# CITY OF NORTH RICHLAND HILLS PLANNING AND ZONING COMMISSION AGENDA 4301 CITY POINT DRIVE NORTH RICHLAND HILLS, TX 76180 THURSDAY, FEBRUARY 18, 2021

**SUBJECT:** RP 2020-11 Consideration of a request from Bohler Engineering for

#### GIBSON ADDITION

#### Development Review Committee Comments | 2/2/2021 Replat Case RP 2020-11 Gibson Addition

CITY PROJECT NO. RP \_\_\_\_\_ REPLAT

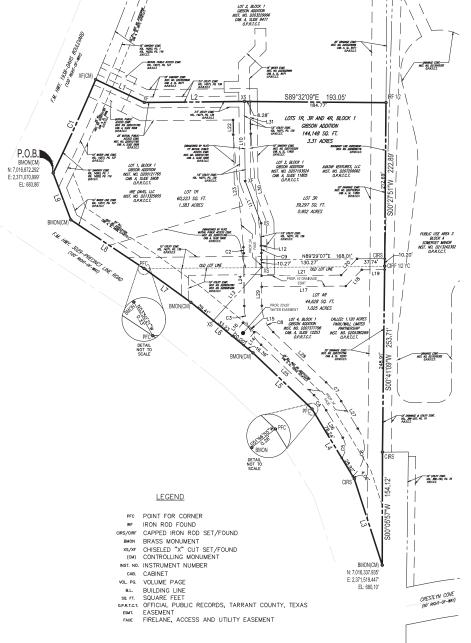
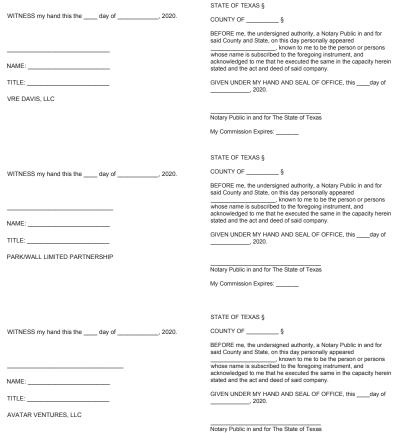
- 1. Increase the scale of the drawing to make the graphic larger. This will help make the drawing more legible, as the dimensions and text are difficult to read at the scale shown. NRH Subdivision Regulations §110-331 (Requirements for all plat drawings scale)

- 2. Increase the line weight of the internal lot lines so that they are differentiated from the other lines on the drawing. It is difficult to distinguish the property lines from easements. NRH Subdivision Regulations §110-331 (Requirements for all plat drawings subdivision boundary)

- 3. On the lots, increase the font size or weight of the text for the new lot numbers and associated acreage and square footage. Lighten or gray out the text for the old lot numbers, recording information, and owner information. NRH Subdivision Regulations §110-331 (Requirements for plat drawings lot and block numbering)

- 4. Add the following County Clerk recording block near the bottom right of the drawing: this plat filed as instrument no. \_\_\_\_\_, dated \_\_\_\_\_. NRH Subdivision Regulations §110-333 (Additional requirements for plat drawings county certification)

- 5. Davis Boulevard and Precinct Line Road are classified as P6D Major Arterial streets on the Transportation Plan. A P6D roadway requires an ultimate right-of-way of 130 feet. Verify the existing right-of-way with established corner monuments on the west side of the street. Right-of-way dedication may be required depending on the width of the existing right-of-way. NRH Subdivision Regulations §110-368 (Street right-of-way dedication) and §110-412 (Generally rights-of-way)

- 6. Add the following note to the plat: This plat does not remove any existing covenants or restrictions, if any, on the property. NRH Subdivision Regulations §110-331 (Requirements for all plat drawings plat notes and conditions)

- 7. Delete note 3. It is not necessary to reference the zoning designation on the plat as the zoning could change in the future. NRH Subdivision Regulations §110-331 (Requirements for all plat drawings plat notes and conditions)

- 8. Add the following note to the plat: The easements indicated on this plat are for the purpose of constructing, using, and maintaining public utilities including underground conduits, manholes, pipes, valves, posts, above ground cables, wires or combinations thereof, together with the right of ingress and egress to operate and maintain the public utilities. NRH Subdivision Regulations §110-331 (Requirements for all plat drawings plat notes and conditions)

- 9. Add and label the sight visibility easement at the driveway intersections on Davis Boulevard and Precinct Line Road. The easement (triangle) is measured 15 feet perpendicular from the intersection of the street right-of-way with the edge of the driveway and 50 feet parallel to the directions of the approaching traffic. The easement may be based on the proposed driveway locations shown on the civil plans. NRH Zoning Ordinance §118-714 (Visibility sight triangles)

- 10. Label all new easements as <u>by this plat</u> rather than <u>proposed</u>, i.e., 15' DRAINAGE ESMT (BY THIS PLAT). NRH Subdivision Regulations §110-331 (Requirements for all plat drawings easements)

- 11. Shade or crosshatch all easements that are proposed for abandonment. NRH Subdivision Regulations §110-331 (Requirements for all plat drawings easements)

- 12. Show and label the approximate city limit line between North Richland Hills and Colleyville. The line is located approximately on the east boundary line of the property being replatted. NRH Subdivision Regulations §110-331 (Requirements for all plat drawings city limit lines)
- 13. Add the following note to the drawing: The city limit boundary does not represent an on-the-ground survey and represents only the approximate relative location of the city limit boundary using various official and unofficial sources. NRH Subdivision Regulations §110-331 (Requirements for all plat drawings city limit lines)
